May 12, 2010
File: 02-0775-50-3939/Vol 01

Re: Addendum #1 3939Q – Hamilton Community Centre – Piling

SK-000
 Revision: 00

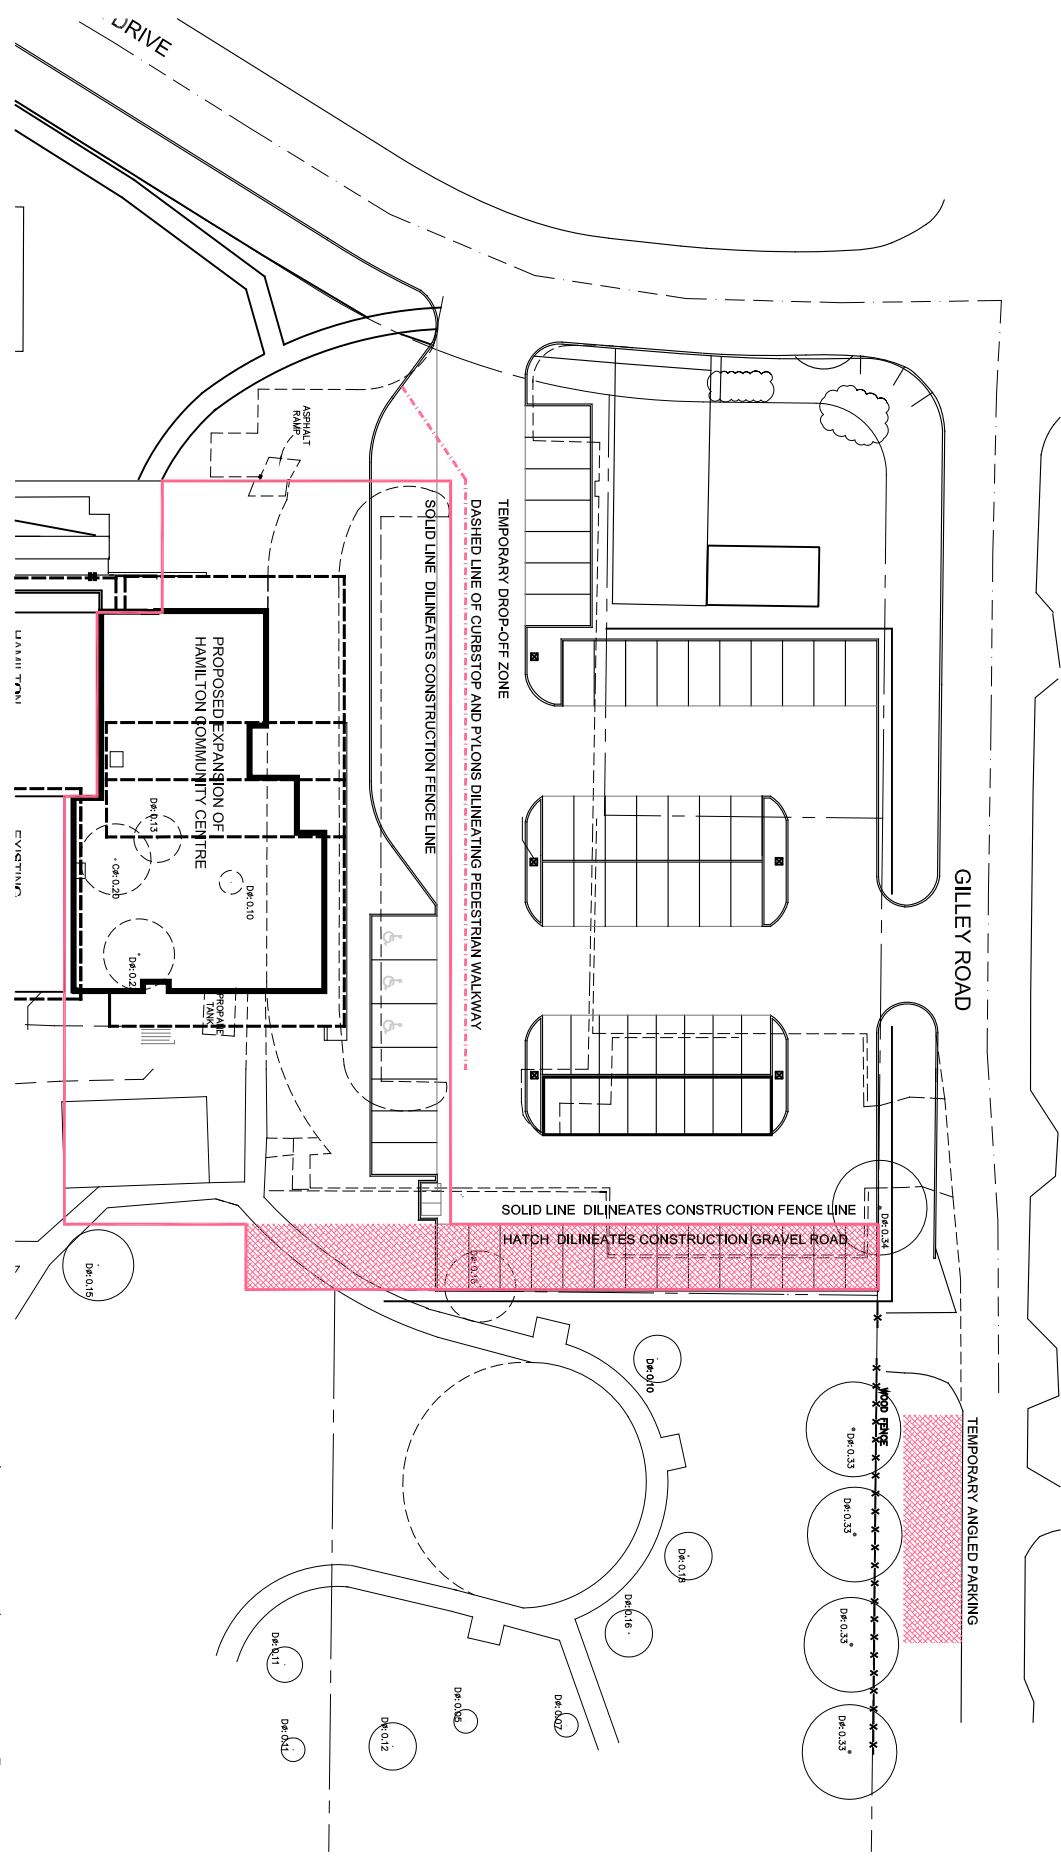
6. Site plan is as shown in SK-000, May 2, 2010. Contractor will be required to access the site from Gilley Road by use of the construction gravel road and work within the construction fence line as shown. Please see attached drawing "Site Plan Construction Hoarding Plan".
